Re: Response to Submissions - MOD 11 Karuah (East) Pit Consolidation Project - MP09_0175-Mod-11 and MOD 2 Karuah (Hard Rock) Pit Consolidation Project - DA265-10-2004-Mod 2

Hunter Quarries (HQPL) has engaged EMM Consulting Pty Limited (EMM) to undertake a review of the advice received from the Water Group within the NSW Department of Climate Change, Energy, the Environment and Water (NSW DCCEEW – Water Group) on 19 June 2026 in relation to the concurrent Modification Applications for the Karuah Pit Consolidation Project as follows:

Figure 1

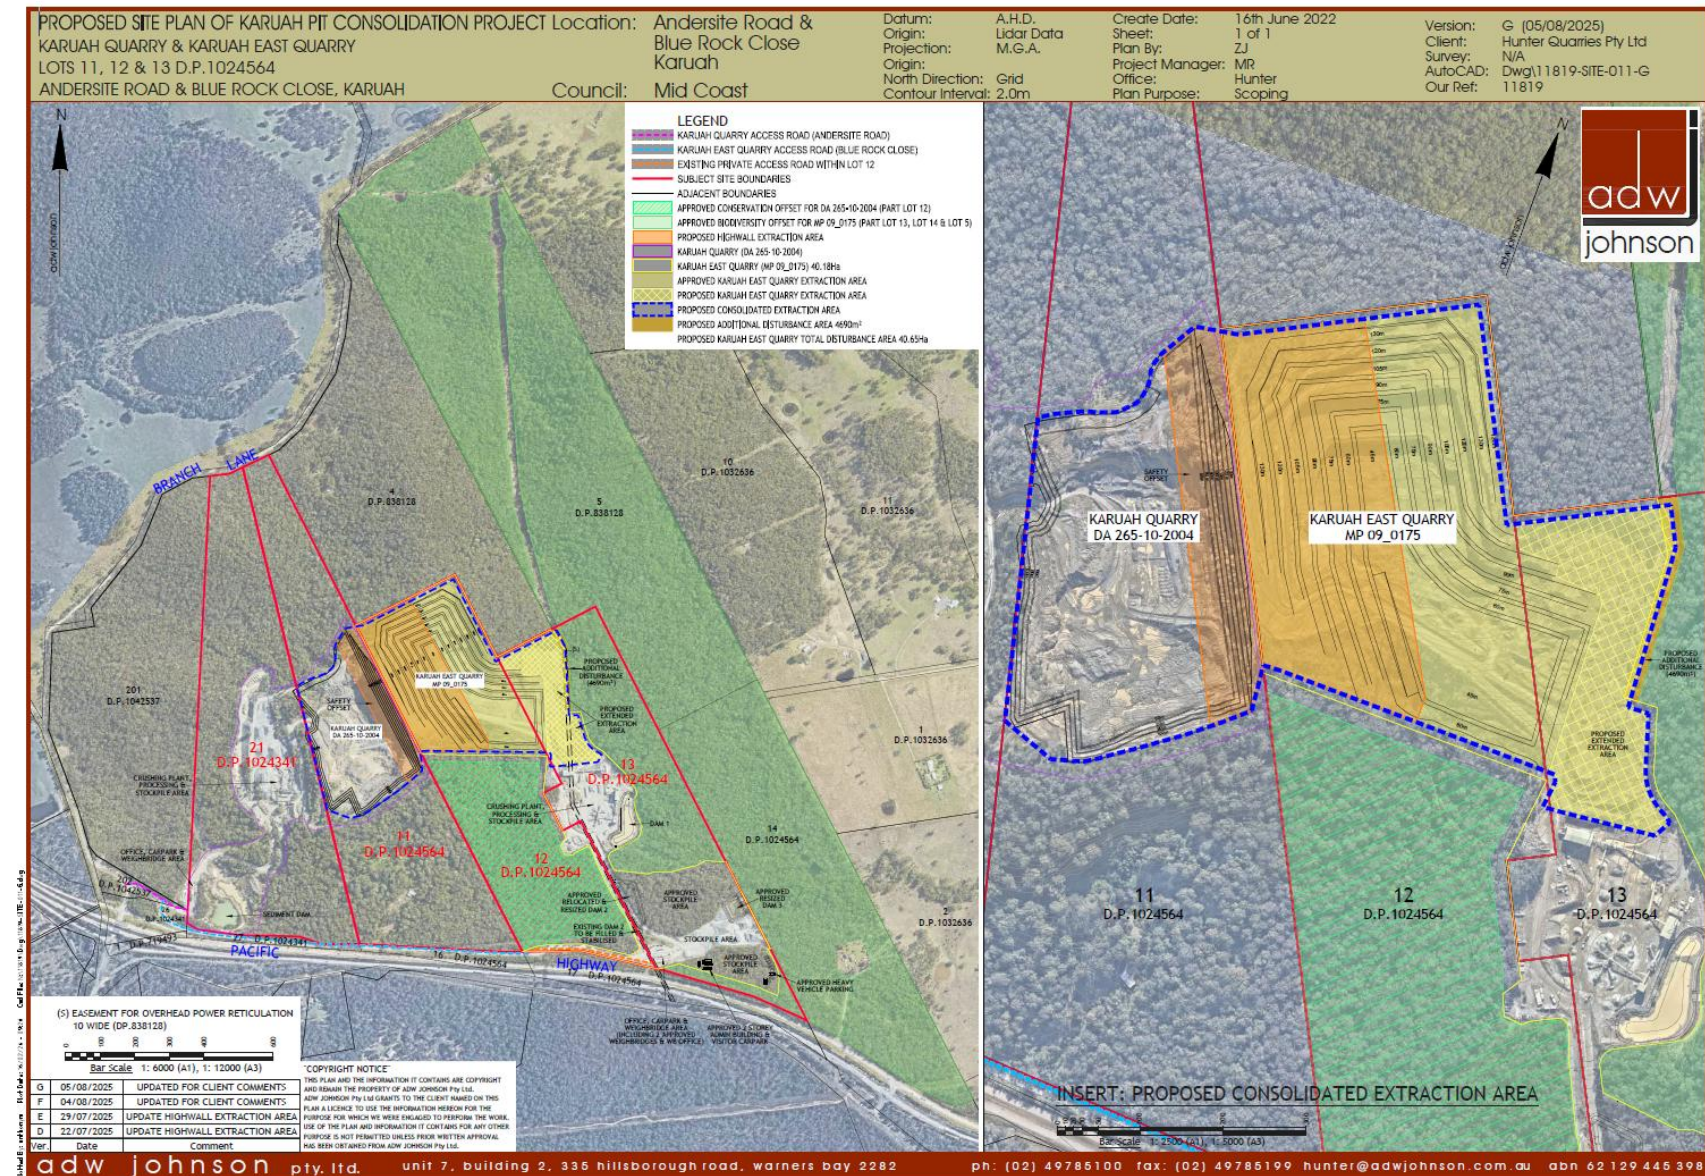
No.	DCCEEW – Water Group comment	Proponent response
1.1	The Department of Planning, Housing and Infrastructure (DPHI) should request that the proponent install two additional groundwater monitoring bores to the north and north-west of the proposed final quarry footprint, to ensure groundwater levels below the proposed floor level of RL 45 mAHD are adequately characterised and monitored.	As requested, two (2) additional groundwater monitoring bores will be installed north and north-east of the proposed Consolidated Extraction Area (CEA). The proposed locations of the bores are shown in Figure 1. The proposed bore on Lot 11 DP1024564 will replace existing bore BH208 which has been decommissioned due on-going maintenance issues associated with the location's steep topography. The proposed bore on Lot 5 DP838128 will address the monitoring gap north-east of the proposed additional disturbance area to the north-east of the site. Both bores will be constructed to a depth greater than the approved KEQ floor level of RL 45 mAHD. The proponent commits to the installation of the two (2) bores on the following basis: a) A new KEQ Groundwater Management Plan will be submitted to DPHI within 6 months of determination of the concurrent Modification Applications (Item 1.2). b) Installation to be completed within 18 months of determination of the concurrent Modification Applications. c) No extraction to occur within the 'Proposed Extended Extraction Area' within the CEA on Lot 13 DP1024564 as shown in Figure 2 until: (i) the KEQ Groundwater Management Plan (refer to Item 1.2 below) has been approved by DPHI (ii) both new monitoring bores have been installed. Until items (a) and (b) have been completed, extraction will be limited to the currently approved extraction areas and the 'Proposed Highwall Extraction Area' within the CEA on Lot 11 and Lot 12 DP1024564 as shown in Figure 2. <i>Note: that the plan provided in Figure 2 is reproduced from Figure 4 of both Section 4.55(2) Modification Reports for the KHRQ and KEQ.</i> Extraction of the 'Proposed Highwall Extraction Area' (as shown in Figure 2) between the two well established quarry pits will not interact with groundwater. This assessment is supported by the absence of groundwater inflows at the existing quarry pits (refer to Section 5 of the Groundwater Assessment that accompanied each Section 4.55[2] Modification Report [Appendix K of both documents]) and depth to groundwater measured using the existing monitoring network.
